**APPLICATION FOR
URBAN DESIGN COMMISSION
REVIEW AND APPROVAL**

PROJECT ADDRESS: 4802 Sheboygan Avenue
ALDERMANIC DISTRICT: District 11

To: Urban Design Commission
From: Brian Munson
CC: Al Martin
Tim Parks
Date: Thursday, June 14, 2007
Re: Hill Farms Redevelopment: UDC Comments

CONCEPTUAL RIGHTS-OF-WAY

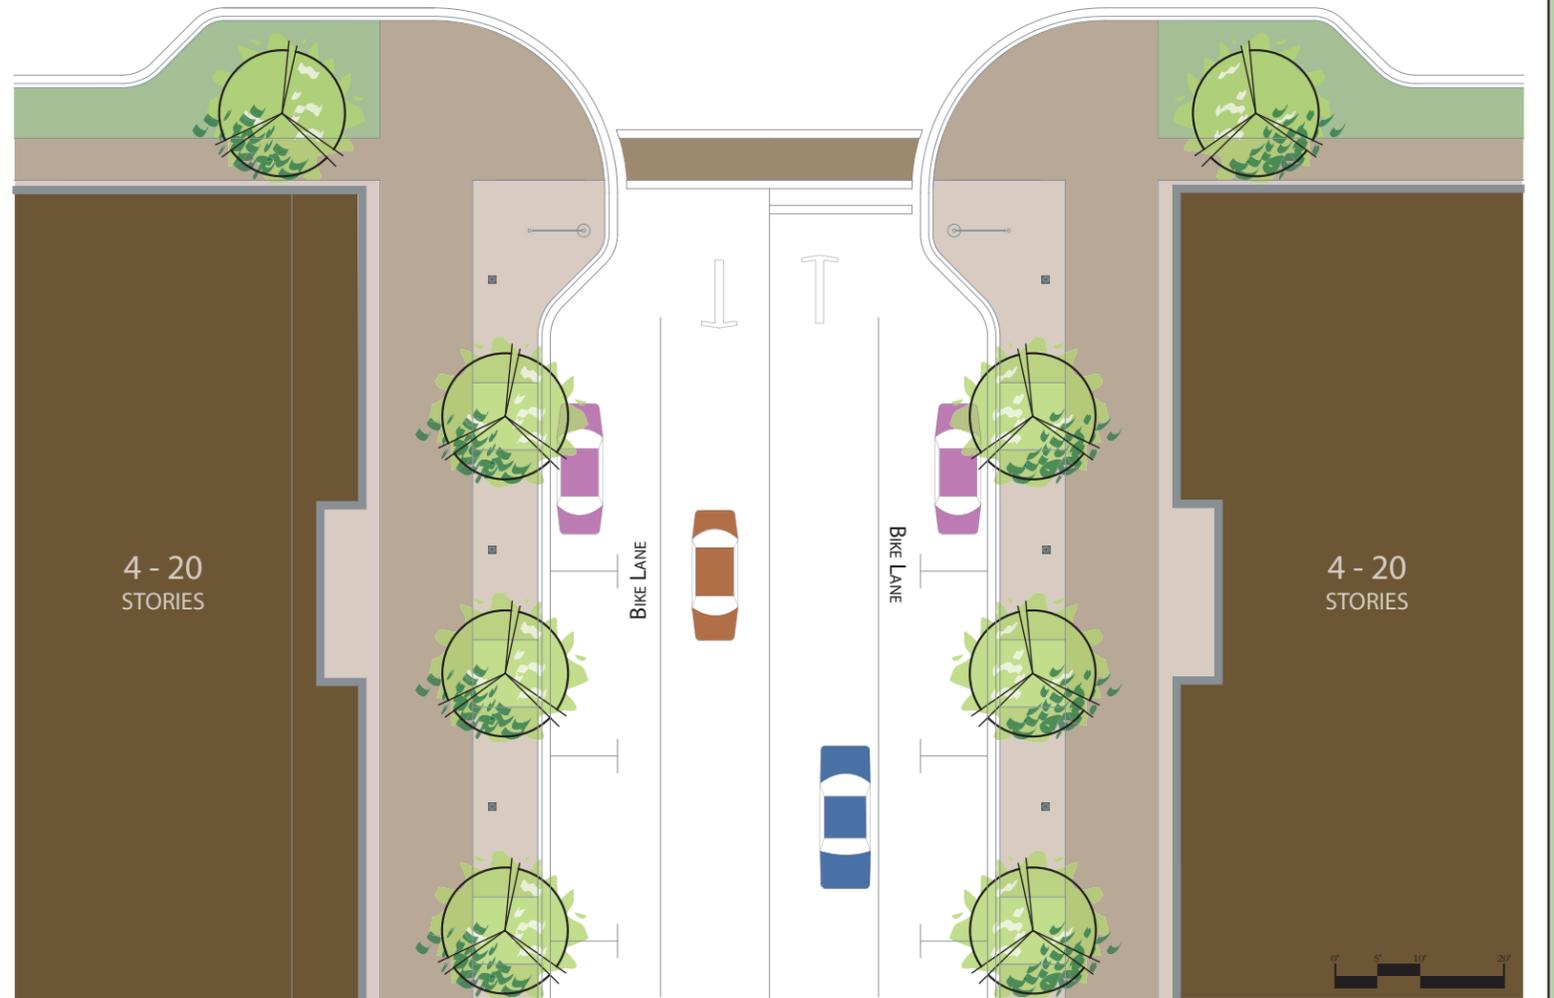
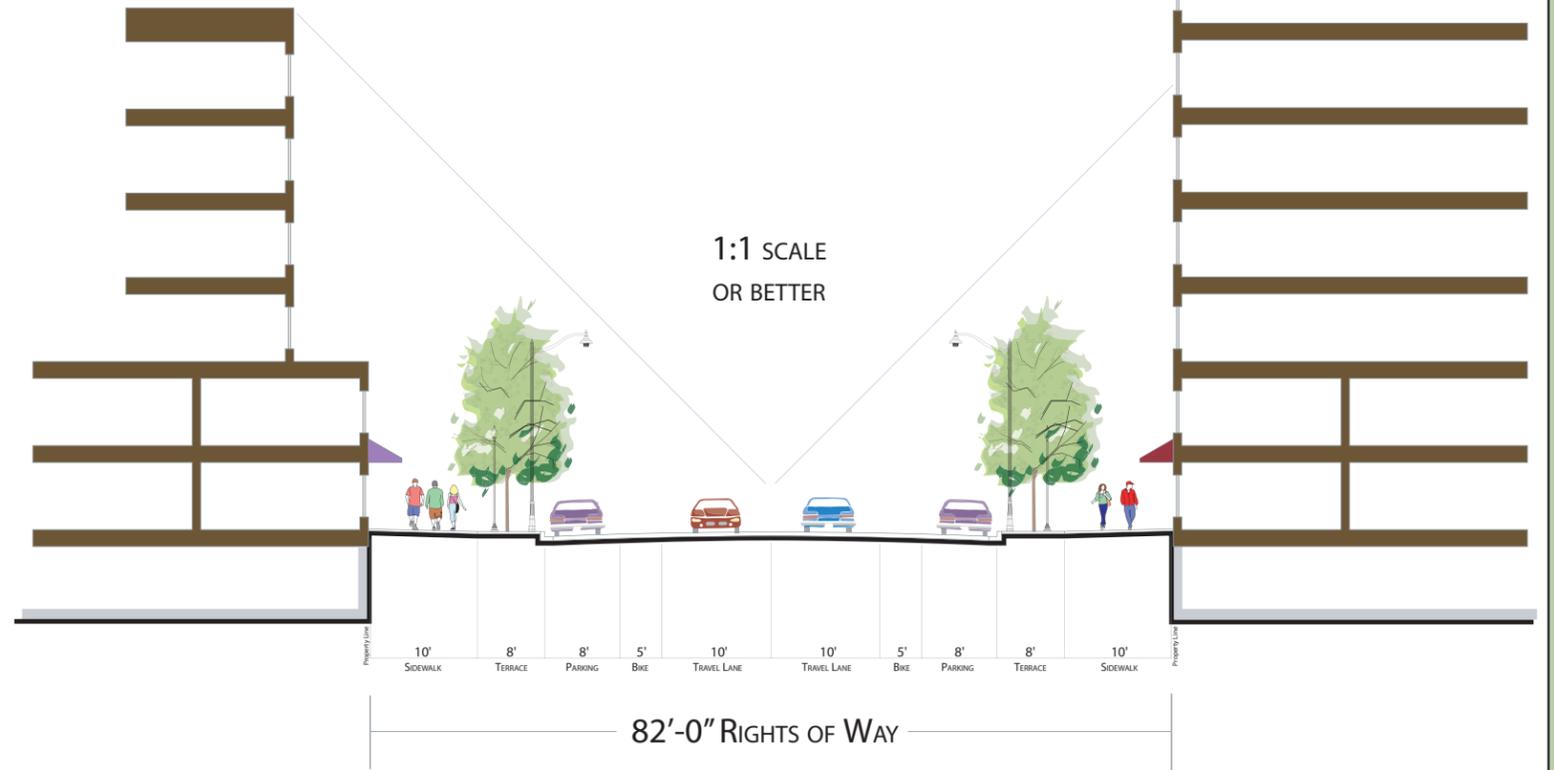
Concern: UDC expressed concern over the width and makeup of the street system within the project, with specific reservation over the width of the streets, incorporation of bike lanes, turning radii, overall travel speeds, and pedestrian orientation.

The revised cross sections include the following changes:

82' Standard Cross Section (previously 90')

Travel lanes reduced from 13' to 10'

Sidewalks/Terrace combination set to 10'/8'

Bike lanes retained (see above)
